GUJARAT STATE DISASTER MANAGEMENT AUTHORITY (GSDMA)  
EARLY WARNING DISSEMINATION SYSTEM (EWDS)  
NATIONAL CYCLONE RISK MITIGATION PROJECT II (NCRMP-II)

Bid Number: IN-GSDMA-115480-RFB

**Minutes of Meeting Pre-bid Meeting for EWDS**

Name of Work: Selection of System Integrator (SI) for supply, installation, testing and commissioning of Early Warning Dissemination System (EWDS) and Emergency Operations Centers as well as Operation and Maintenance and Annual Maintenance Contract Services under NCRMP-II Project.

Figure-5: Message dissemination network architecture

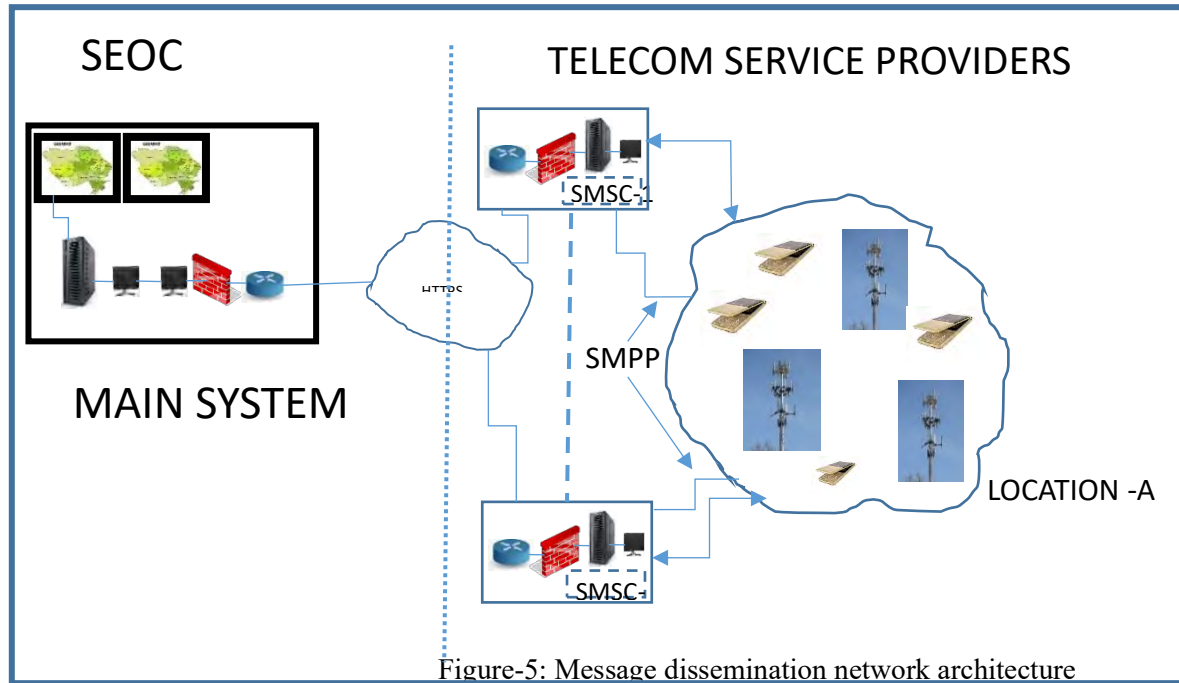
S.No	Section No, Clause No Page No	Description	Query/Suggestion	Response
222	Page 190	Figure-5: Message dissemination network architecture	<p>a) What does "SM" in the figure stand for? Please clarify.</p> <p>b) The SMSCs are numbered <b>SMSC-1</b> and <b>SMSC-3</b>. Connection to more than one SMSC is not mentioned in scope of work for GMS. A single SMS Sending Engine connected to GMS via SMPP can send to subscribers of all telecom operators in the state.</p> <p>c) Architecture diagram implies Location based Alerting and is in contradiction for Group Messaging as per defined scope, wherein the alert will only go to contacts / groups and is not based on current Location of the subscribers. Kindly advice and confirm the same.</p>	<p>"SM" refers to "SMPP" here. Location based alerting is not included in the requirement. Understanding that current location of the recipient is not in current scope.</p>
